RE: Project File Number, Brown and Jackson, SE-20-00003

Our written comments submitted are in regard to Washington State Environmental Policy Act (SEPA), Chapter 43.21C RCW, and Kittitas County Grading Permit public notice Brown and Jackson, SE-20-00003, dated, Monday, August 17, 2020. It is of our understanding that Kittitas County is acting as SEPA Lead Agency for the proposed project and proposed SEPA project actions and that Kittitas County is reviewing Brown and Jackson's June 11, 2020 Kittitas County, Department of Public Works, Grading Permit Application. However, based on review of the documents we understand we are commenting on the project as a whole, including, but not limited to, Washington State Department of Ecology's General Permit for Biosolids Management.

BROWN & JACKSON
 Land Application Site
 Preliminary
 Site Map
 Kittitas County Washington

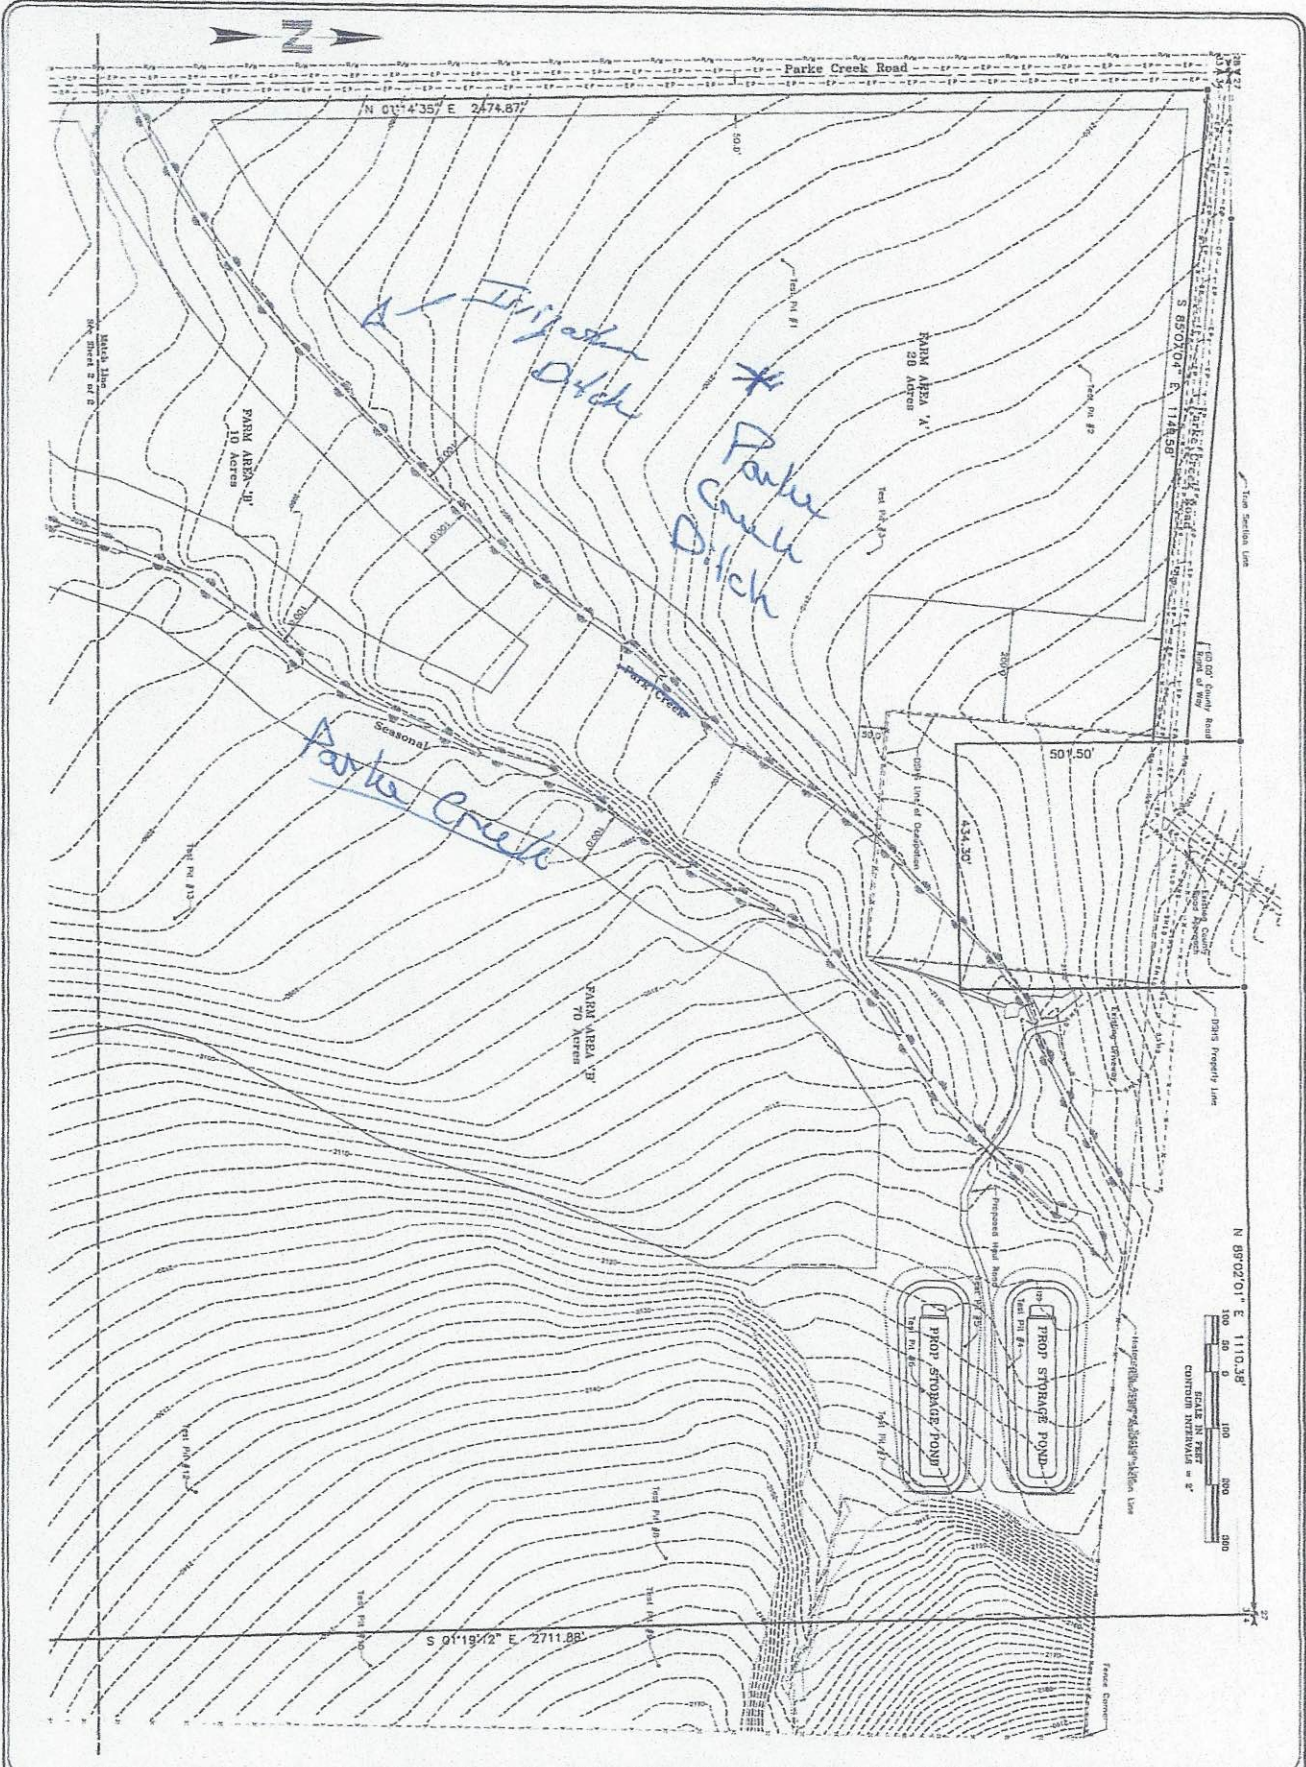
A.12.: Included Preliminary Site Plan does not appear to locate features, such as streams and irrigation ditches accurately. Included map in the July 30, 2020 Western Pacific Engineering and Survey document improperly characterizes Parke Creek's location with respect to the fields and proposed storage ponds. Parke Creek is the water body flowing from the north to south on the eastern-center portion of the site. The irrigation ditch, locally known as Parke Creek Ditch, flows from the east to the west across the site conveying irrigation and stock water to farms and ranches several miles downstream of the site. Please update maps and labeling.

Corrections to the map are included in Attachment 1.
